CASE COMMENT REPORT

CASE NO. UDP-S24028

CASE:	UDP-S24028
MEETING DATE:	May 14, 2024
REQUEST:	Site Plan Level II Review: Multifamily Development with 22 Units in the Central Beach Regional Activity Center
APPLICANT:	Blue Skies Realty Investment, Inc.
AGENT:	Joseph Kaller, Kaller Architecture
PROJECT NAME:	Granada Condominiums
PROPERTY ADDRESS:	3003 Granada Street
ZONING DISTRICT:	A-1-A Beachfront Area District (ABA)
LAND USE:	Central Beach Regional Activity Center
COMMISSION DISTRICT:	2 - Steven Glassman
NEIGHBORHOOD ASSOCIATION:	Central Beach Alliance HOA
CASE PLANNER:	Nancy Garcia

UDP-S24028 - 3003 GRANADA ST.

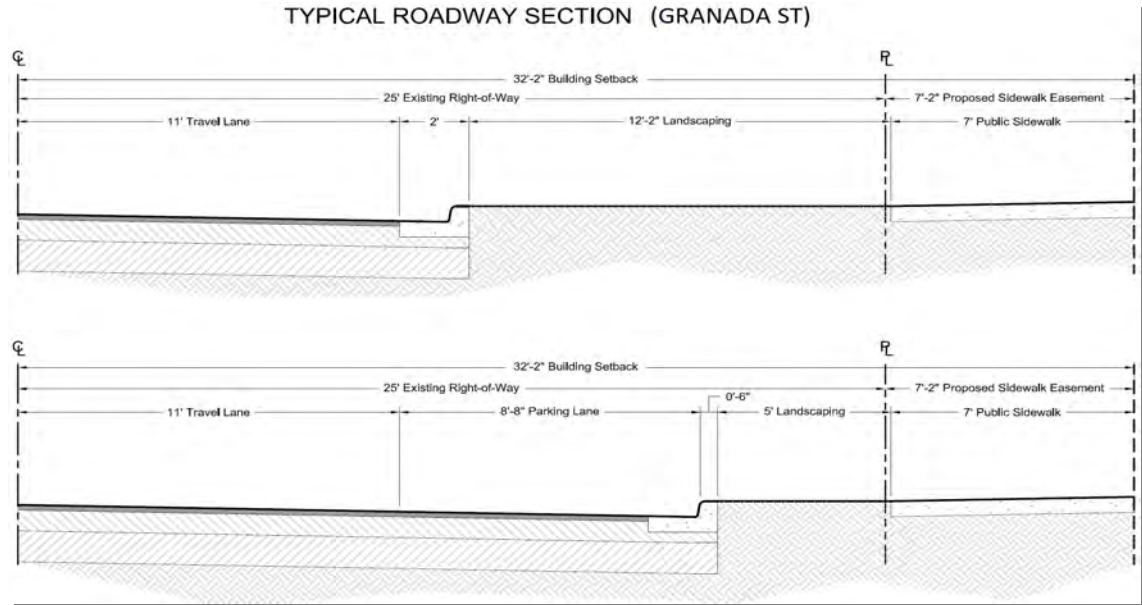
- g. The ground floor contains a significant amount of unusable green space, specifically along Birch Road. The image below demonstrates how the sidewalk should be shifted in towards the property to allow for a more visually appealing streetscape:
